# UNITED STATES PATENT AND TRADEMARK OFFICE

APPLICATION NO.	FILING DATE	FIRST NAMED INVENTOR	ATTORNEY DOCKET NO.	CONFIRMATION NO.
09/545,834	04/10/2000	Shuhie Harada	Q58793	3167

# Office Action Summary

## DETAILED ACTION

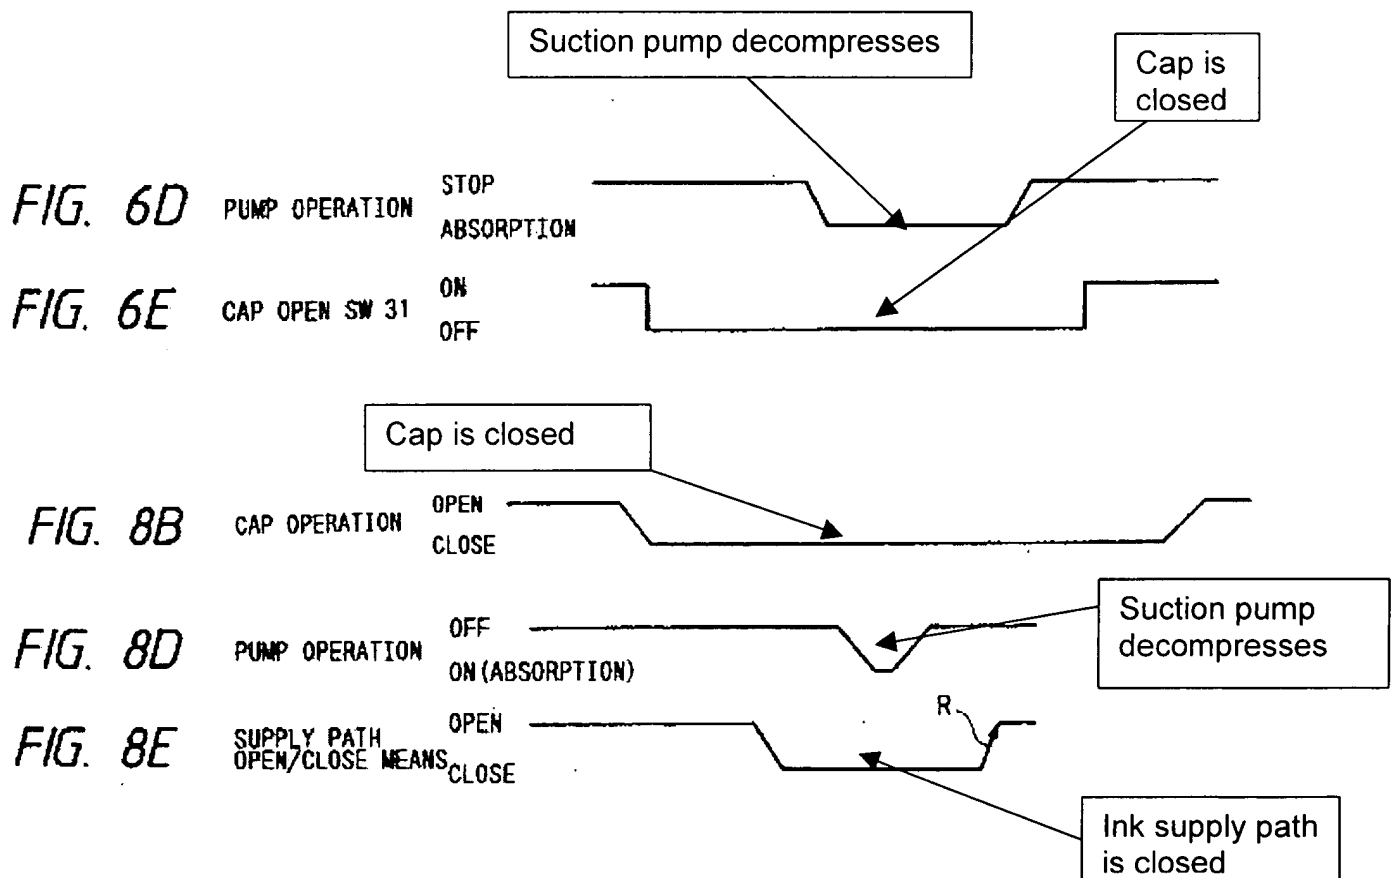
- A suction pump for reducing pressure (Fig.1: element 20);
- A control unit for controlling the valve unit, the capping unit and the suction pump unit (Fig1: element 56) such that: the valve unit closes the ink flow passage, the capping unit seals the nozzle orifice, the suction pump decompresses the internal space of the capping unit and the valve unit opens the ink flow passage a predetermined time period elapses (Column 6: line 3-19, Fig. 8E);

- The suction pump decompresses the internal space of the capping unit under a condition that the valve unit closes the ink flow passage and the capping unit seals the nozzle orifice (Fig.8B-8D: shows at the first operation pump, the cap and the supply path are closed)

- The capping unit such that the decompresses state of the internal space of the capping unit is maintained while the suction pump is driven (Fig.6D-6E)
- The suction pump continues decompressing the internal space of the capping unit for a second predetermined time period (Fig.6C+6D);

With respect to claim 71, Terasawa et al. discloses the step of stopping to drive the suction pump after a second predetermined time period has elapsed since the ink flow passage was opened (Fig.6C-6D).

With respect to claim 72, Terasawa et al. discloses the step of driving the suction pump between the sealing step and the closing step (Fig.6C-6E).

With respect to claim 73, Terasawa et al. discloses the step of driving the suction pump again after the stopping step has executed (Fig.6D).

With respect to claim 74, Terasawa et al. discloses step of releasing the capping unit from the nozzle orifices after the suction pump has driven again and driving the

suction pump again to discharge ink from the nozzle orifices in a capping released state (Fig.6D-6E).

Applicant's argument that Terasawa et al. does not teach the controller controls the capping unit such that the decompressed state of the internal space of the capping unit maintained while the suction pump is driven is not persuasive. Refer to figure 6D and 6E, clearly shows that the cap is closed when the pump is operated.

**FIG. 1****FIG. 2**

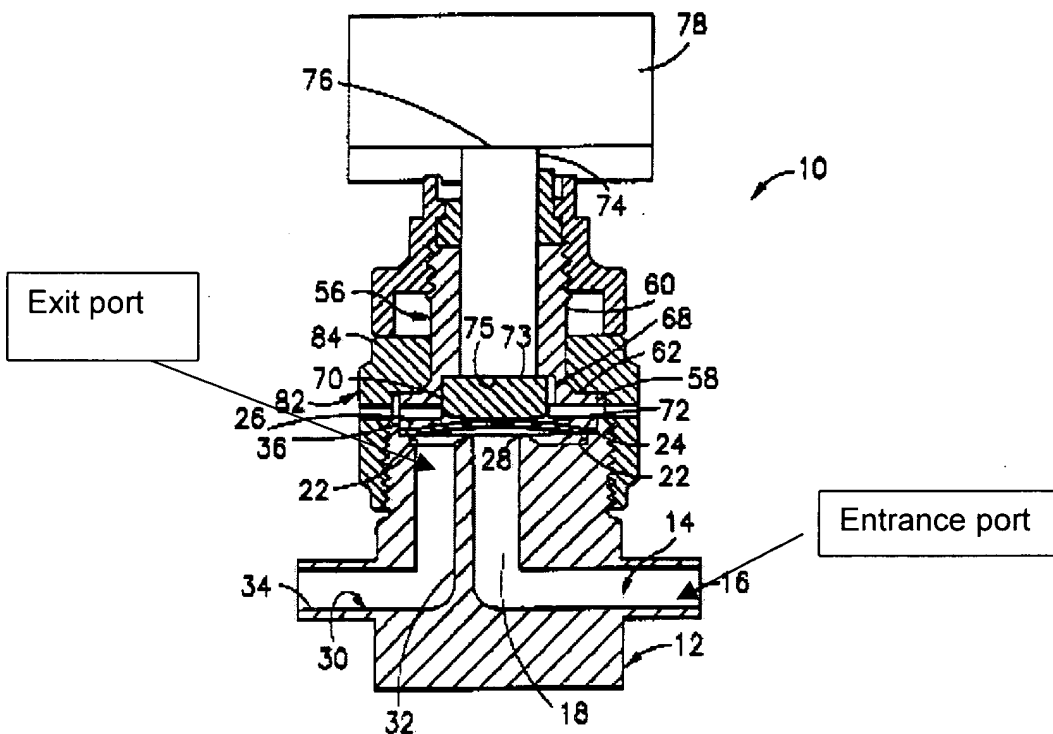
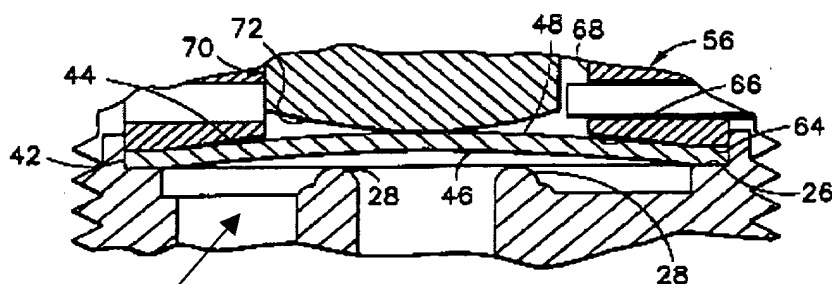
Wu et al. teaches a valve control chamber (fig.1: element 20), a flexible diaphragm (Fig.3: element 40), an actuation body (Fig.1: element 74+78), valve control chamber has an entrance port formed on a top wall thereof at a portion where is away from the center portion of the diaphragm and an exit port formed on the top wall (Fig.1), the entrance port is arranged below the exit port (Fig.1), the circumferential portion of the exit port is tapered (Fig. 2), the diaphragm includes an annular convex portion (Fig. 2: element 48) and the actuation body is a rod member (Fig. 1: element 70+74).

Exit port is tapered (larger on the top and smaller on the bottom)
